MEMORANDUM

To: Design Review Board
From: Jon Regala, Senior Planner
Date: May 13, 2013
File No.: DRV12-01340
Subject: 450 CENTRAL WAY MIXED USE PROJECT DESIGN RESPONSE CONFERENCE
(CONTINUED FROM APRIL 15, 2013)

Re: Response to 4.15.2013 DRB guidance meeting

VIEW FROM CENTRAL OF "SAIL" OPTION (B)

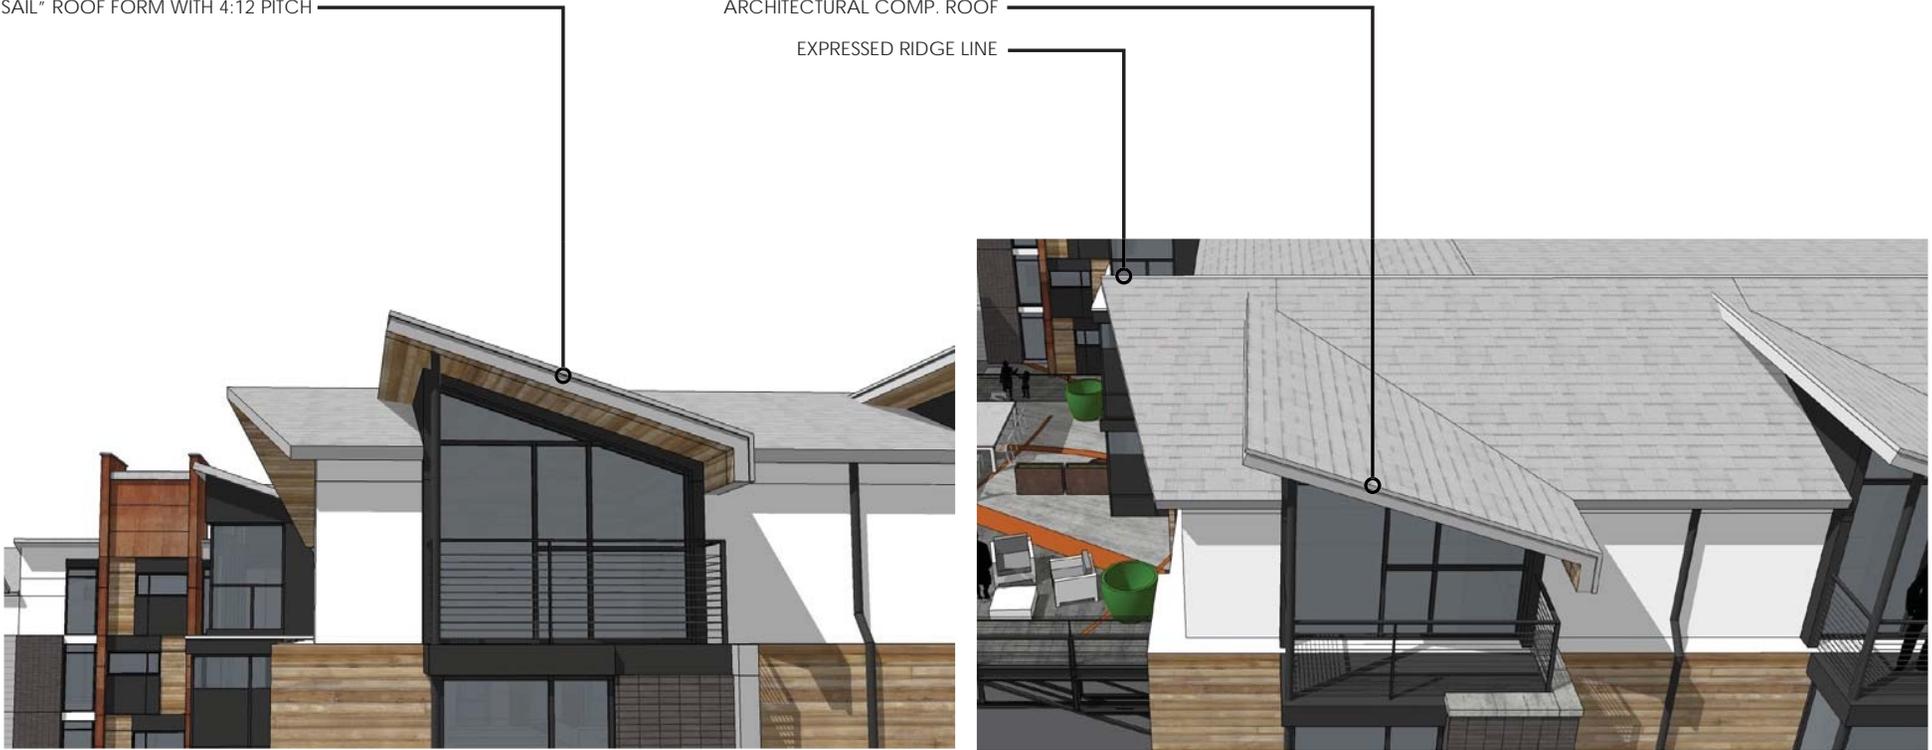
A topic of concern was the building aesthetic along Central Way. While the DRB appreciated the residential architectural character for the majority of the project, especially where facing the condominiums to the north, the DRB was concerned that the upper stories along Central Way did little to express the urban character found at the base of the ground floor. The proposed peaked composition roof design, the material palette, and use of vinyl windows were questioned by the DRB as to whether they were appropriate to the location.

During their deliberation, the DRB asked that the Central Way façade reflect the urban aesthetic successfully created at the ground floor by bringing more of the pedestrian arcade materials to the upper stories. Another suggestion was to incorporate a similar shed roof design found on several buildings fronting the main courtyard area to the Central Way facade. Even with these potential changes, the DRB asked that the requested urban aesthetic should still integrate well with the northern residential buildings design.

- a. The first alternate is a traditional bay expression carried to the fifth story and terminated with a reverse shed at 4:12 pitch. The team feels this would be an acceptable solution but feels it to be a ubiquitous urban form and not as sophisticated or "Kirkland authentic" as alternate "b".
- b. Using the beach as inspiration for our material palette we returned to that source for inspiration of alternate two. We are expressing the roof forms as lateral pitched shed roofs at minimum 4:12 pitch. The resulting geometry evokes the form of a sail on boat, open to the prevailing wind and consequently the views to the southwest. We find this expression to be unique, urban and well-suited for the balance of the building design. As the building turns into the courtyard the end gable has been tapered to create a dynamic form supporting the geometry of the sails, metaphorically

resembling the prow of ship. This form also bridges the shed roof expressions at the upper central courtyard with the Central Way façade.

MATERIAL OPTION A VIEWS

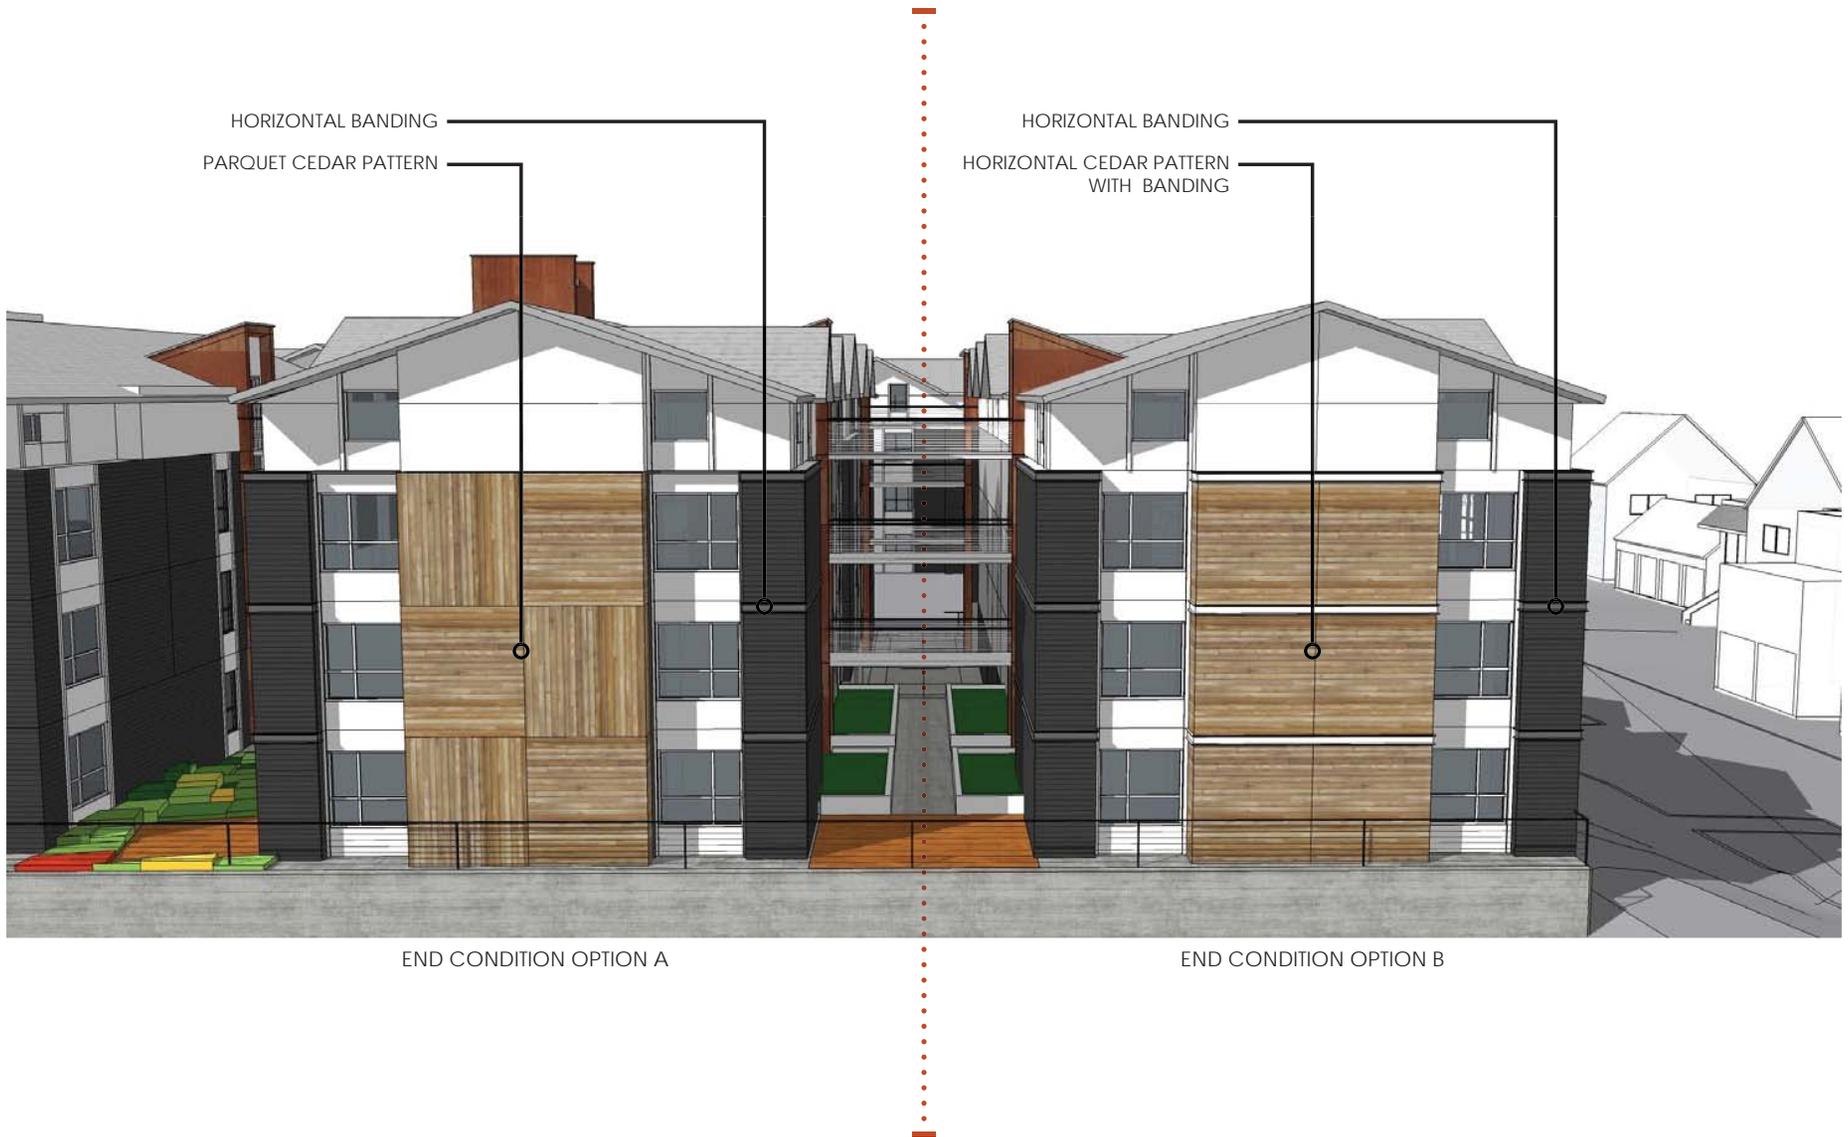
Some board members suggested more compatibility between the arcade and the upper stories along Central Way. We believe much of this will be resolved with the preferred solution of item 1 above. To further support the pursuit of compatibility, the team assembled three material distribution studies:

- a. This alternate maintains the cedar main field with brick accents at the bay projections that match the colonnade finish below. This supports contrast with the base below by honestly expressing the differing functions of the commercial space below and the residential above.
- b. We have "married" the upper stories with the base by utilizing the same brick material as the main field material. Cedar accents at the bay projections maintain some of the warmth and residential expression.
- c. This alternate is similar to option B but with more contrast at the bay projections. The resulting design embodies a more "coastal" design response.

DETAIL VIEW OF BANDING

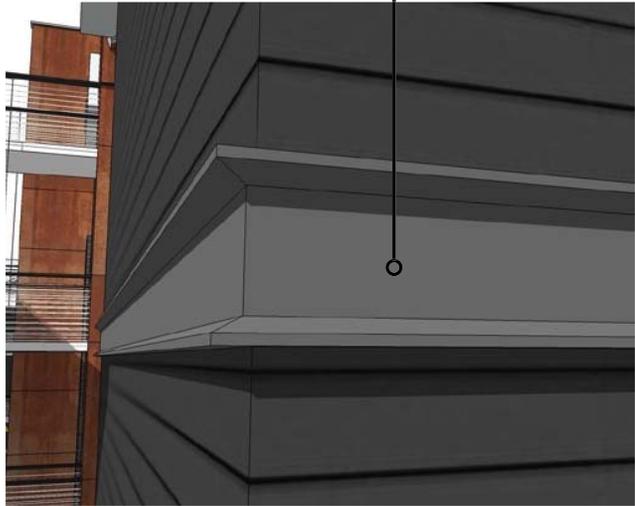
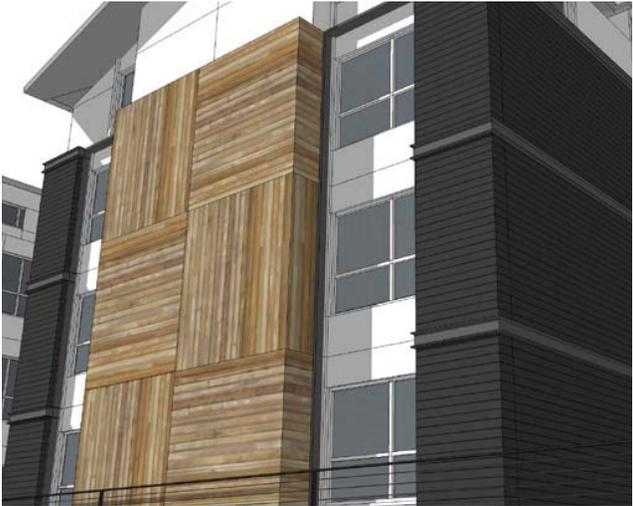
The DRB liked the proposed material and color palette for the project. The DRB agreed that the colors and materials used were successful in reflecting a northwest beach and Kirkland aesthetic. However, the DRB requested that the applicant explore breaking up the larger vertical expanses of cedar used at various areas around the project. The main concern the DRB had was the eventual appearance of cedar after 5+ years.

The team analyzed several options to mitigate the larger expanses of singular siding. In celebration of the historic Peter Kirk steel ambitions (Pittsburg of the west), we have incorporated metal banding expressions at the floor lines to break up the larger expanses of siding. The profile provides shade, shadow, relief and overall visual interest.

At the cedar siding areas of buildings 1, 2 & 3, we again turn to history and were inspired by Native American use of the cedar bark into "textiles" for bags, rugs, and clothing. The resulting "parquet" or "weave" breaks down façade into subtle compartments demonstrating craft and visual interest.

EXPRESSED STRUCTURE ESTABLISHES GATEWAY TO COURTYARD

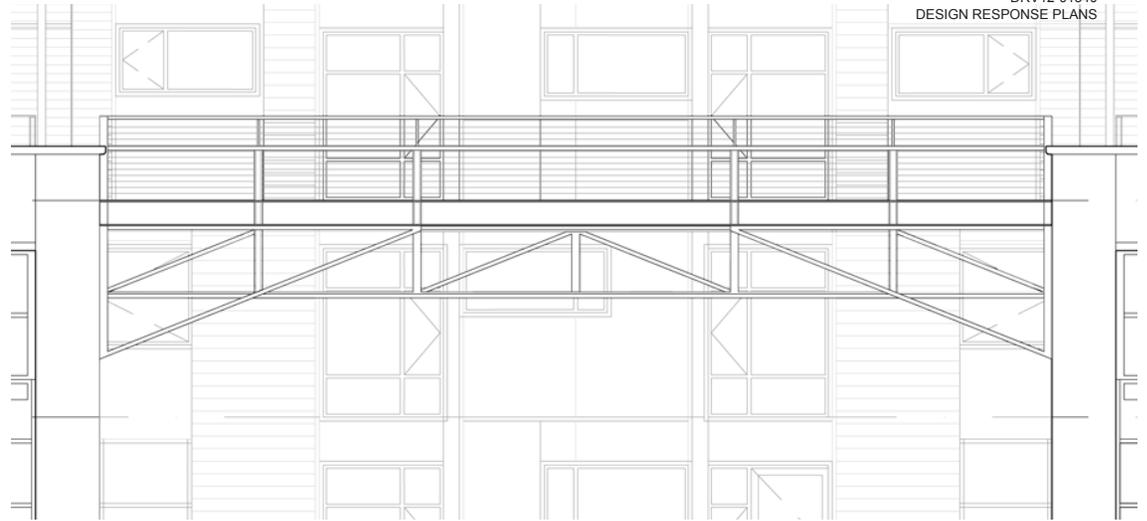
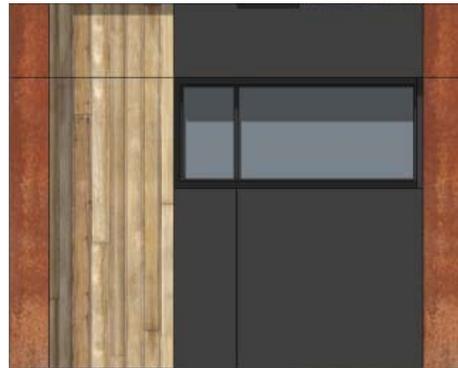
The DRB also noted that having the elevator feature at the end of the courtyard was a nice focal point and requested that its design be played up since it will have a major role in the courtyard experience. Another concern expressed by the DRB was the 3rd story deck above the courtyard. Comments suggest that the deck should be made more integral to the composition of the courtyard and the surrounding buildings.

We have enhanced the design of the bridge structure to be more expressive and tectonic. The result is a rich blending of the brick and steel evoking an historic palette of utilitarian, honest uses. The bridge form reinforces passage to the rear courtyard, a gateway, yet maintains a light, tracery element to maximize the passage of light, air and visual access.
